MEADOW LANE, IFFLEY

TA TECHNICAL AUDIT

PROJECT NO. 4989-2001 DOC NO. TN02

CLIENT: FRIENDS OF IFFLEY VILLAGE

Figure 2-1: Location of Oxfordshire County Council Quiet Route OXR18 in relation to site

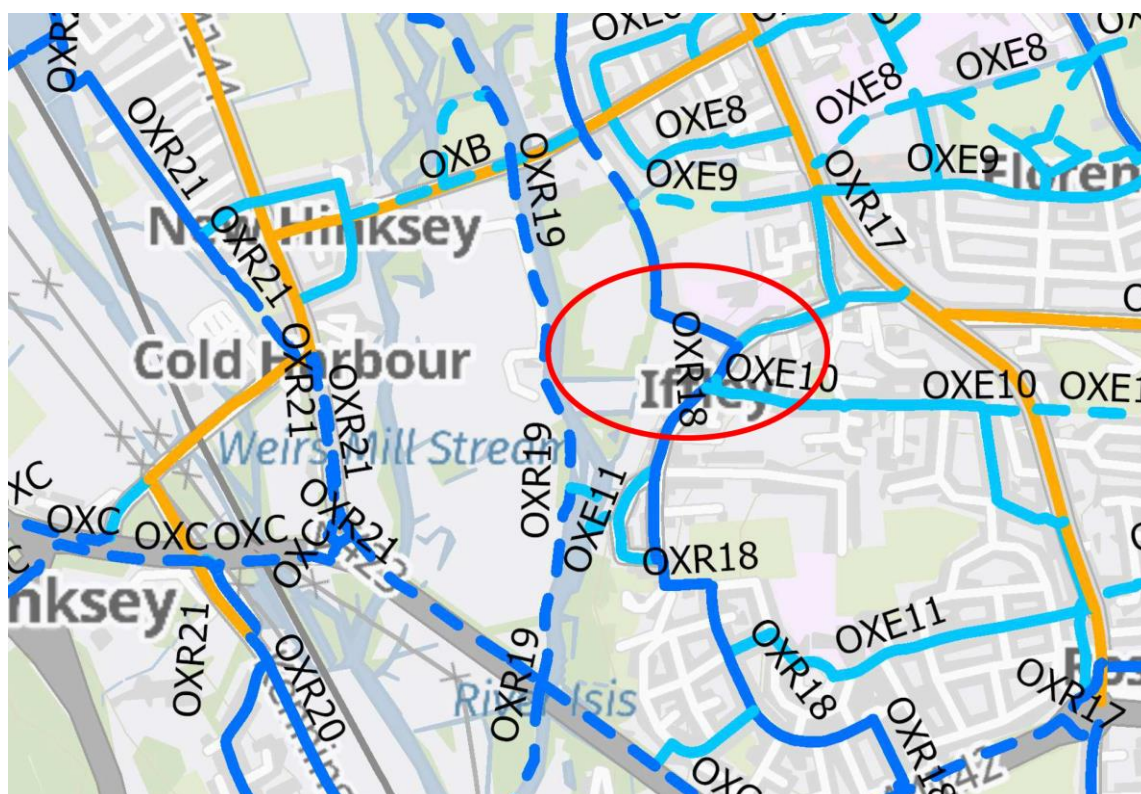
- 2.1.6 Notably, the TA fails to acknowledge the presence of Oxfordshire County Council's Quiet Route OXR18 which runs past the site on Church Way and Meadow Lane. This route provides a key pedestrian, cycle and equestrian route used by residents and visitors for commuting and recreation activities. The route is shown in **Figure 2-1**, with the site circled in red. There is no analysis within the TA on how the proposed development will impact upon the amenity of pedestrian, cycle and equestrian access on the route and as a result, the safety implication of the proposed development on OXR18 have not been assessed or mitigation proposed.

- 3.1.5 Notably, the TA fails to acknowledge the presence of Oxfordshire County Council's Quiet Route OXR18 which runs past the site on Church Way and Meadow Lane. This route provides a key pedestrian, cycle and equestrian route used by residents and visitors for commuting and recreation activities. The route is shown in **Figure 2-1**, with the site circled in red.

| Drawing Title MEADOW LANE JUNCTION WITH CHURCH WAY | | | | |

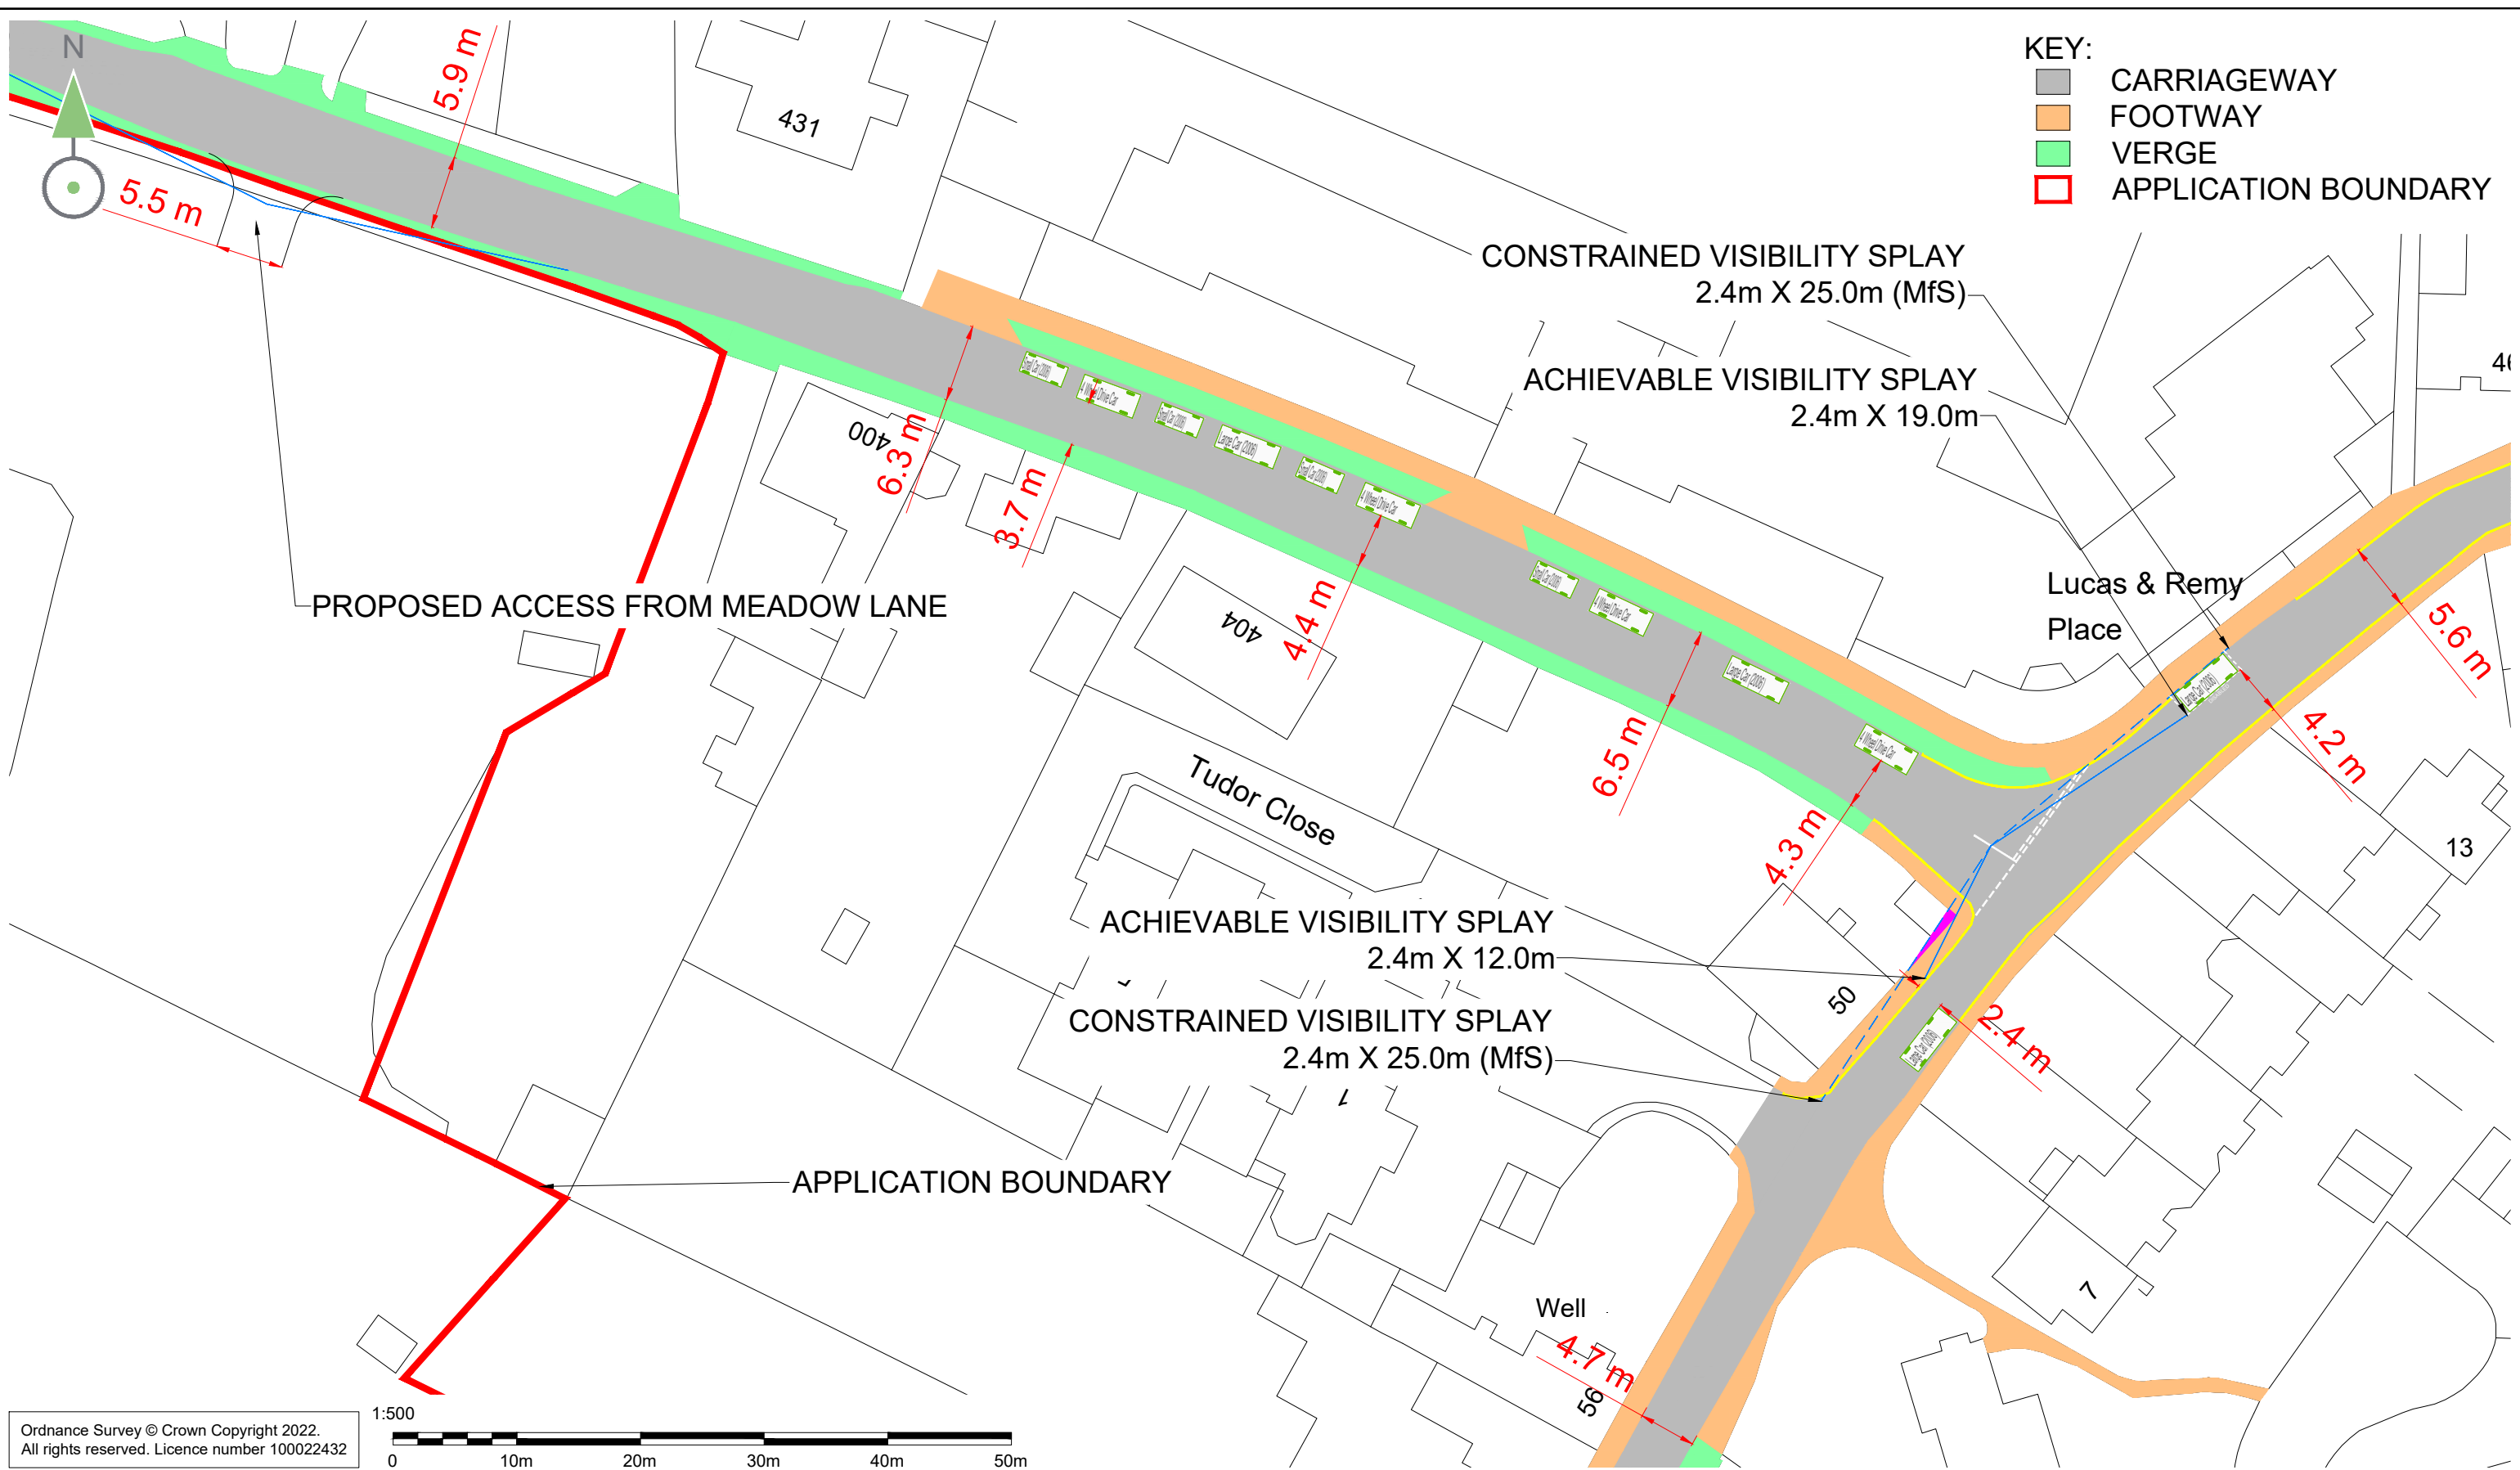
2.3.1 VTP Drawing **4989-2001-T-001** Rev A – Meadow Lane Junction with Church Way, a copy of which is included within **Appendix A** of this Technical Audit, presents the visibility constraints of the existing priority junction. Church Way is identified as being a 20mph road.. It is noted that traffic surveys were undertaken in January 2022 along Meadow Lane, and the results are presented in Section 3 of the TA that supports the application. These results identify that the 85th percentile speeds along Meadow Lane were recorded as being 14.5mph in an eastbound direction and 16.3mph in a westbound direction. As such, the consultants consider that a design speed of 20mph along Meadow lane is robust. This is agreed. However, no speed data was recorded along Church Way which as the main access road to the village.

2.3.2 In accordance with Table 7.1 of the Department for Transport's (DfT) Manual for Street's (MfS), visibility splays at junctions of this nature should include a setback distance of 2.4m and relate to the appropriate stopping sight distance (SSD) for vehicles approaching Meadow Lane from Church Way, which is identified as being 25.0m for a 20mph design speed. Drawing **4989-2001-T-001** shows that the required visibility splays of 2.4m x 25.0m are not achievable in either direction.

- 2.3.5 To the south, the achievable visibility splay is identified as being 2.4m x 12.0m, which is constrained by an existing property (land coloured pink). To the north, the achievable visibility splay is identified as being 2.4m x 19.0m, which is constrained by the existing on-street disabled parking bay. As such, the required visibility splays, in accordance with MfS, cannot be achieved. Therefore, any increase in traffic flows at this junction should mitigate the impact that they create, which would be to provide suitable visibility at a junction that is already constrained. There are no proposals set out within the TA to make improvements at the Meadow Lane/Church Way junction or even an acknowledgement of its existing sub-standard design.

- 2.3.6 Whilst this is an existing junction with constraints that make it potentially outside the control of the Applicant to improve the junction, it is our view that this is an unacceptable approach given that the use of the junction will be intensified as a result of the proposed development and therefore safety implications associated with inadequate junction visibility will be exacerbated. This is particularly relevant to inter-visibility with cyclists who use Meadow Lane, and this is discussed in further detail below under Accident Data. Further, given the intensified use of the Meadow Lane/Church Way junction and its sub-standard inter-visibility provision, it is recommended that this junction is also subject to a Stage 1 Road Safety Audit (RSA).

- 2.3.7 Drawing 4989-2001-T-001 Rev A also shows the limited carriageway width on Church Way and Meadow Lane, particularly where this is further restricted by parked cars. The development proposals include the provision of cobbles on Meadow Lane to delineate the beginning of the current shared surface section of the carriageway. Cobbles provide a difficult surface for people with mobility problems to walk on, as well as creating an uneven surface for equestrians, wheelchair users and pushchairs for children.. Further cobbles provide increases in tyre noise from motor vehicles, creating increased noise impacts for existing residents.
